NRL/MR/7441--94-7550

Digital Mapping, Charting, and Geodesy Analysis Program Technical Review of Interim Terrain Analysis Data Set Prototype 1

August 12, 1994

Figure 1. Common Open Water (SA010) from SDRAREA.AFT

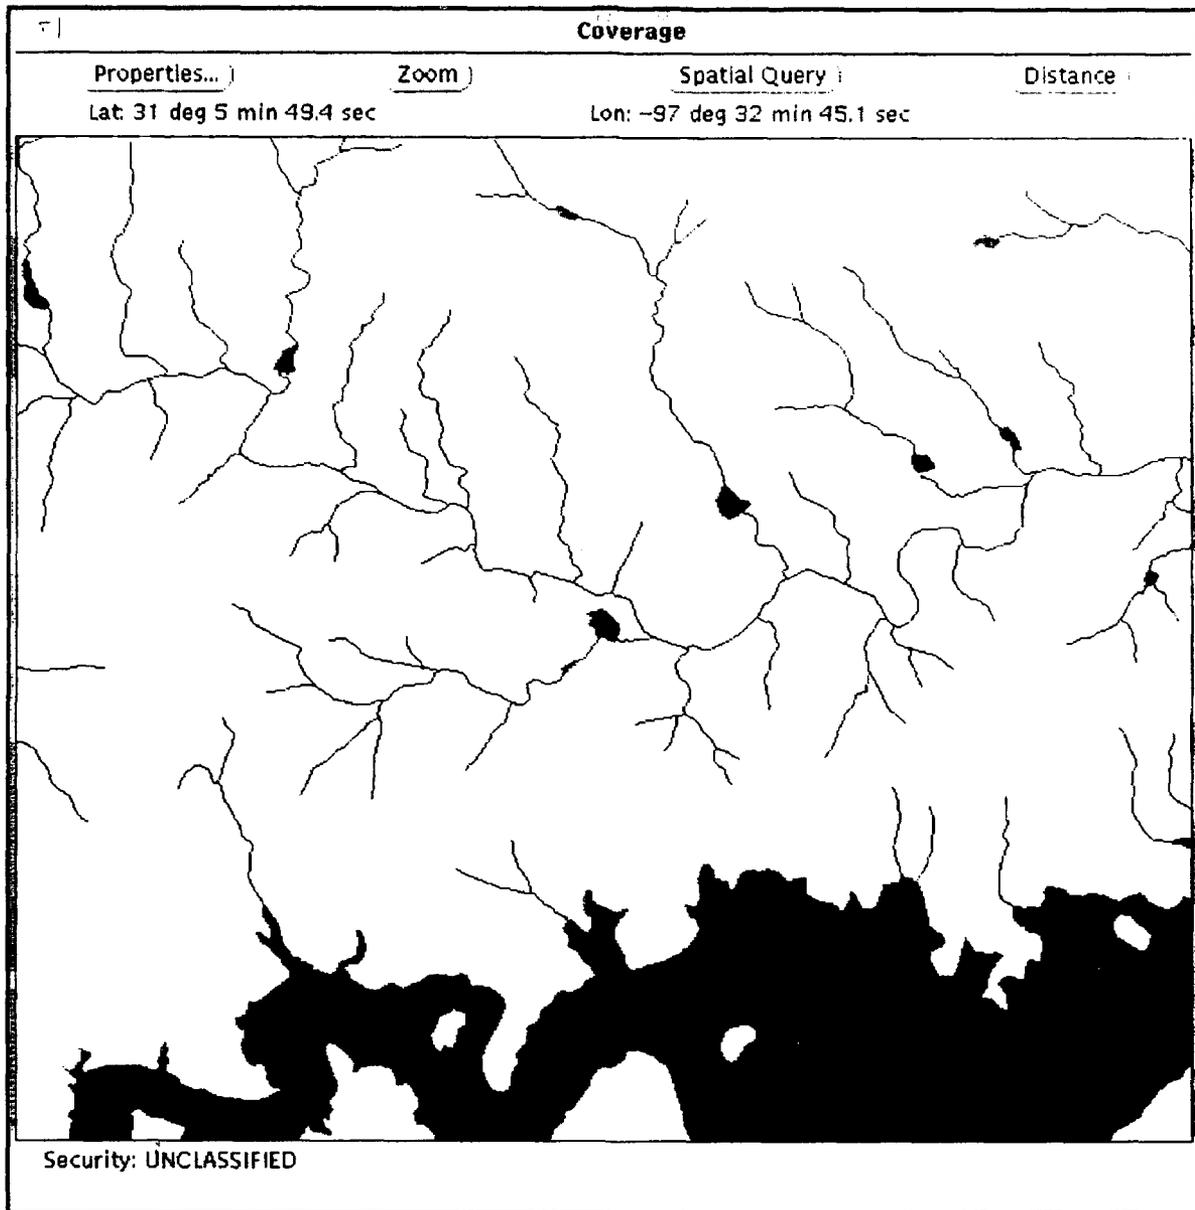
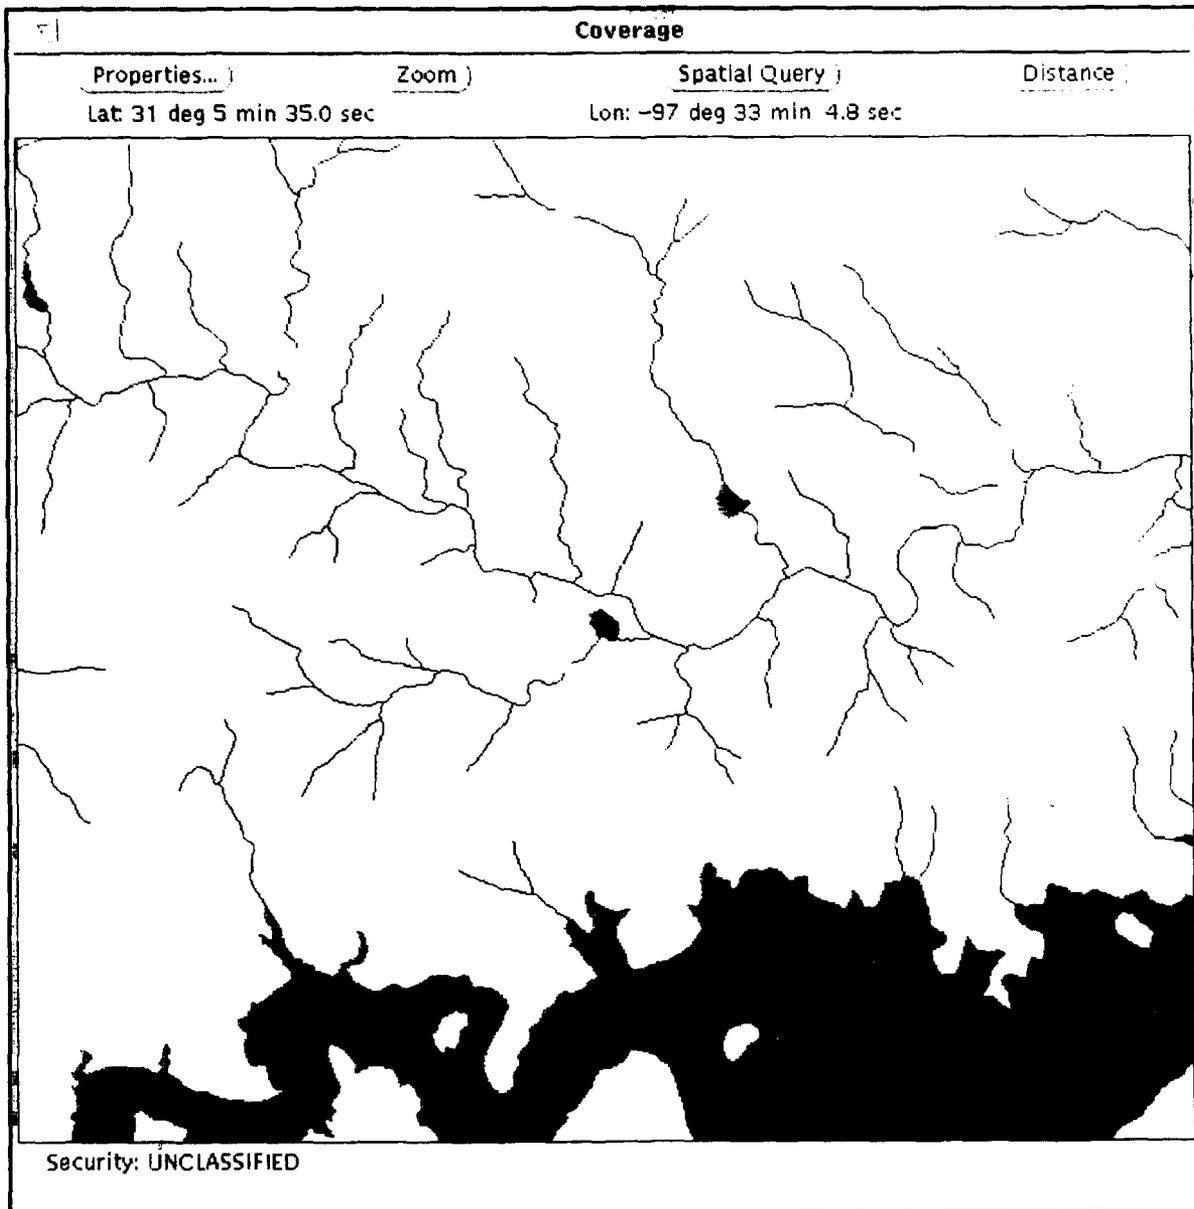
- The Common Open Water feature (SA010) is defined in the following four Feature Classes:
SLWAREA SMWAREA
VGWAREA SDRAREA

Data are found in SLWAREA, VEGAREA, and SDRAREA. When SA010 is plotted, some of the resulting open water areas do not appear in all coverage. There are approximately 30 features found only in SDRAREA. For example, a small lake (0.4 miles long, 0.1 miles wide) appears only in SDRAREA at 31° 8' 0.7" N, 97° 36' 36.8" W.

The problem appears to be primarily due to the definition of "Open Water." In the surface drainage coverage, where Rivers are stored, certain wide areas in the rivers are defined as "Open Water," while in other coverages both of these areas and the Rivers are not defined. This results in a difficult to interpret set of coverages. For instance, if SA010 in VEGAREA is used to display lakes and BH140 (Rivers) are displayed from SDRAREA, there will be gaps in some of the Rivers. Examples of this problem are shown in Figs. 1 and 2. Note that in Fig. 2 not only are several lakes missing but the Rivers (BH140) now have unexplained gaps in them.

Figure 3. Built-up Areas (AL020) in Red

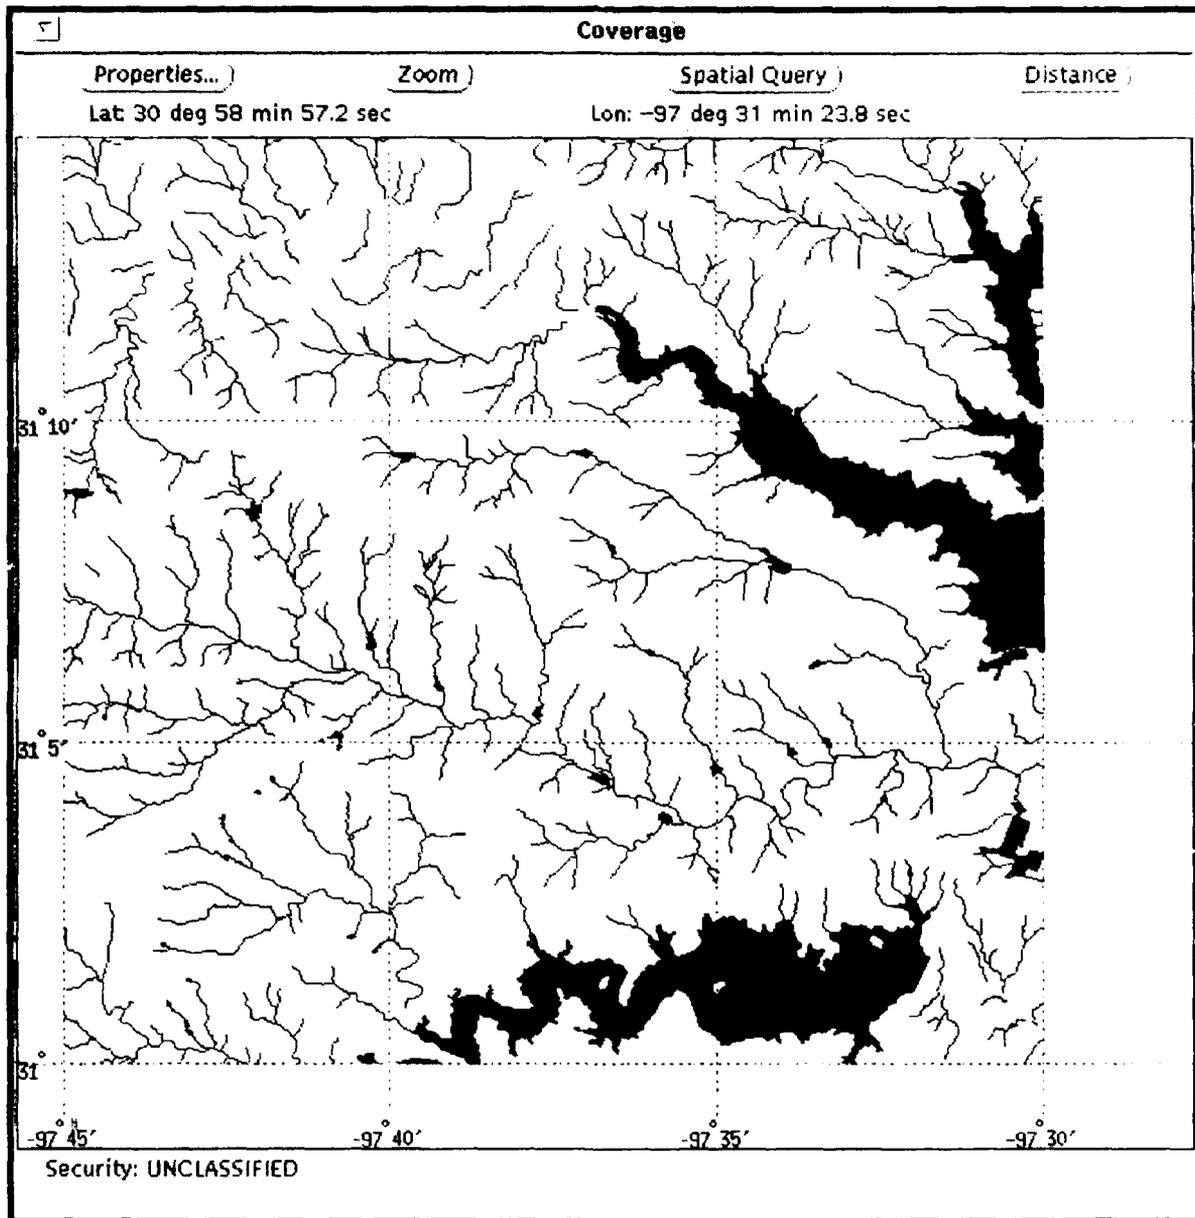
- There is a database error in the Built-up Areas table. When the feature Built-up Areas is displayed, the following face appears:
 - Face 34:
 - VGWAREA.AFT

- ID-Row Identifier: 7
 - FAC-ID-34
 - F_CODE- SA010.
 In fact, it is a lake that is displayed, but it appears with other Built-up Areas. This is shown in Figure 3. The feature AL020 (Built-up Areas) from VGWAREA.AFT is displayed in red.

Figure 4. Rivers in Area and Line Feature Classes

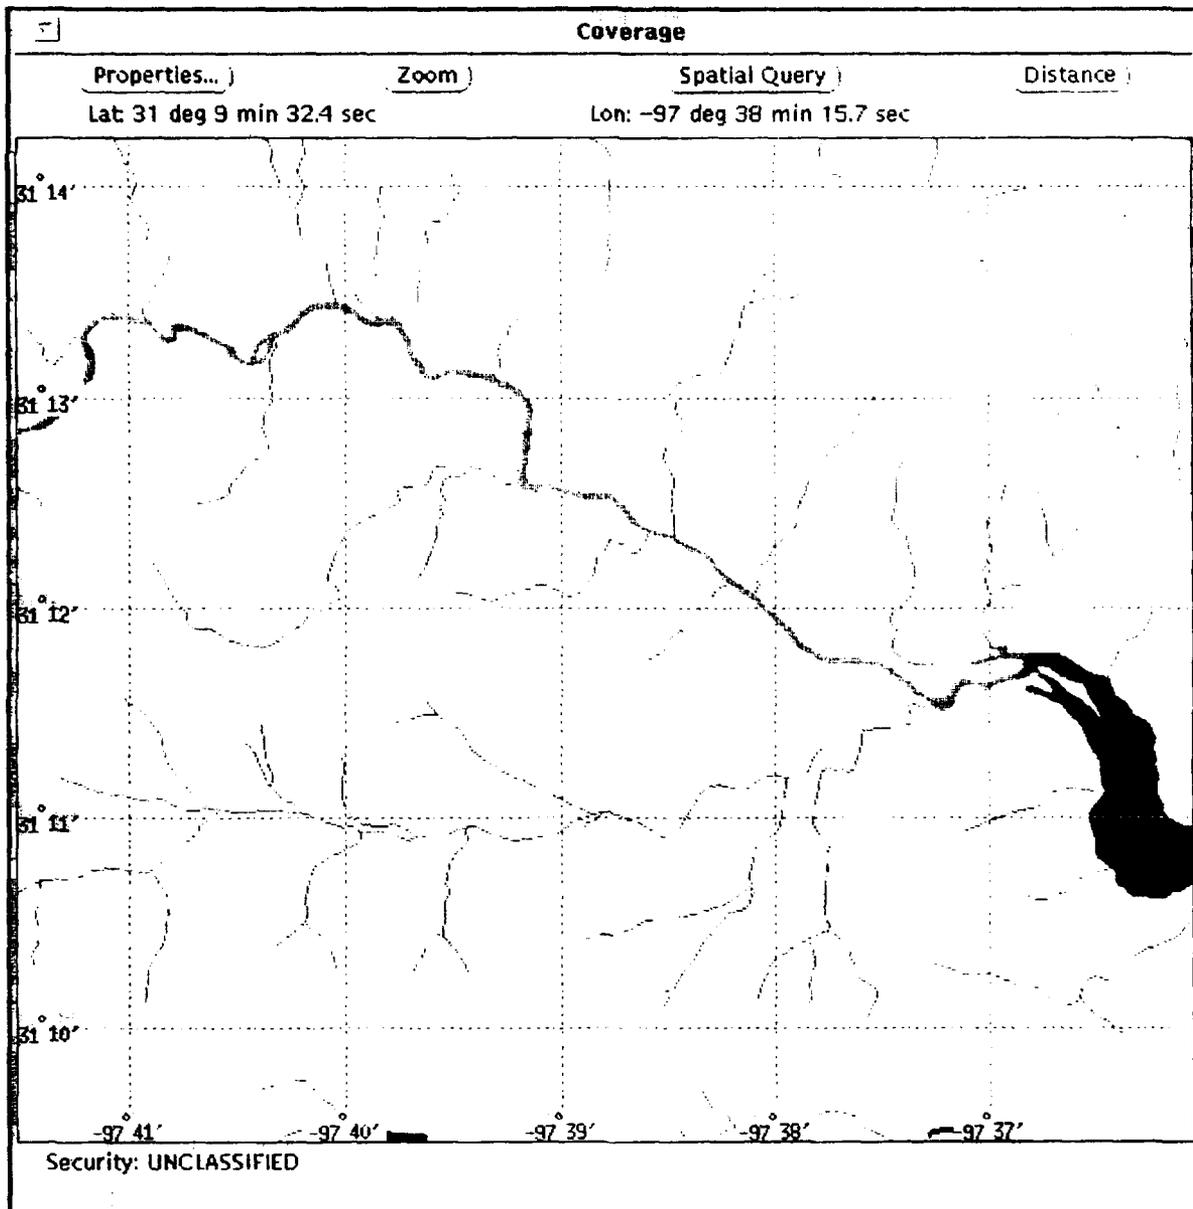
- It is not clear when a river is a line or area feature. As shown in Figure 4, there is a significant river area feature among the river line features. It is recommended that the criteria for coding river features be specified.
